KSF250-A1 Kawasaki CLUTCH COVER	MC 88-05 May 20, 1988
---	---	-------------------------------------

SERVICE INFORMATION

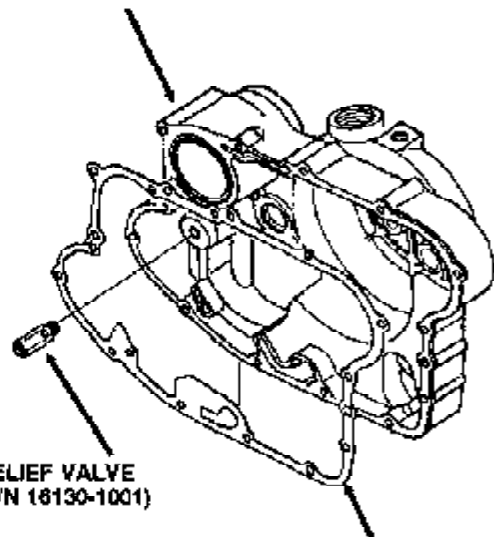
On some early production 1987 KSF250-A1 All Terrain Vehicles, extremely high oil pressure that builds up during cold weather starts may result in damage to the oil filter cover.

A new clutch cover that incorporates a threaded hole to allow for installation of an oil pressure relief valve is now available.

CLUTCH COVER
(P/N 14032-1251)

RELIEF VALVE
(P/N 18130-1001)

CLUTCH COVER
GASKET
(P/N 11009-1589)

- o The relief valve is not supplied with the new clutch cover and must be ordered separately. Install the relief valve inside the clutch cover as shown.
- o The new clutch cover uses the same gasket as the old one.
- o See Service Manual (P/N 99924-1067-01) for cover removal and installation.
- o Torque for the relief valve is 1.5 kg-m (11 ft-lbs, 14.7 N-m). Install the relief valve with a permanent locking agent.

- o Failure to install relief valve will cause severe engine damage due to lack of oil pressure.
